Project:	2022-RFT-026 821131 – Solid Waste WTS Construction		
Addendum No.	07	No. of Pages:	6
Date:	2022-08-23	Doc. No.:	P7201-1591092266-192(1.0)

The purpose of this Addendum is to clarify and answer for bidder's question on tender 2022-RFT-026 issued for bid on July 12, 2022.

Question 8:**REF: DRAWING WTS-S06**

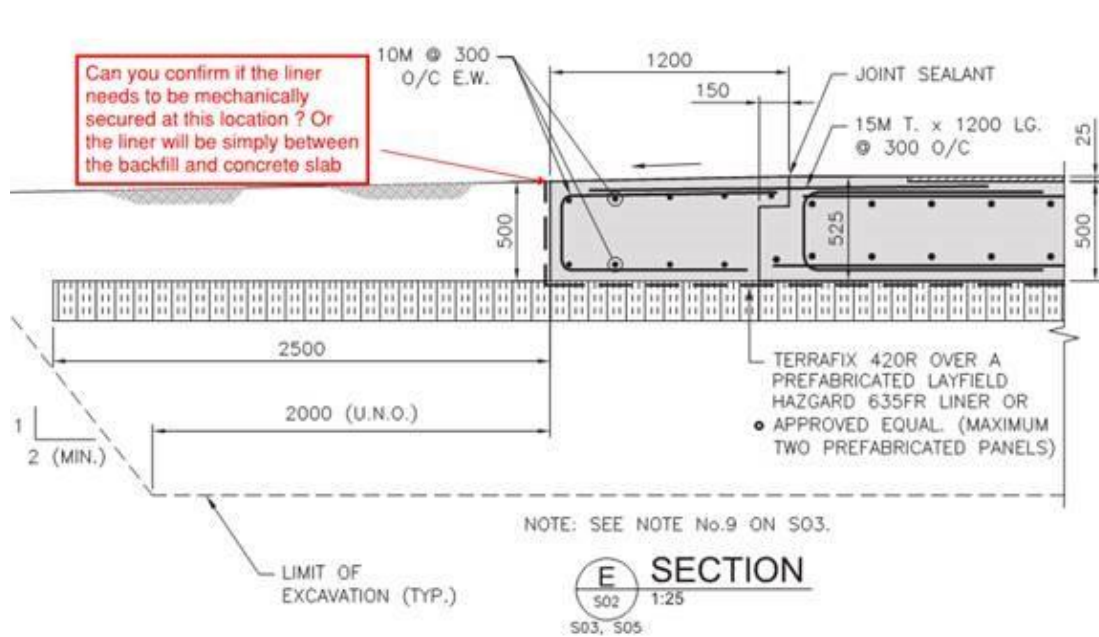
Detail 3/WTS-S06 shows a galv. Kwik bolt along with an angle around the perimeter. Can you confirm how we are to seal the geomembrane liner at this location?

We refer you to Addendum 6 Drawing WTS-06 Slab Sections and Details, Item 2 for clarification.
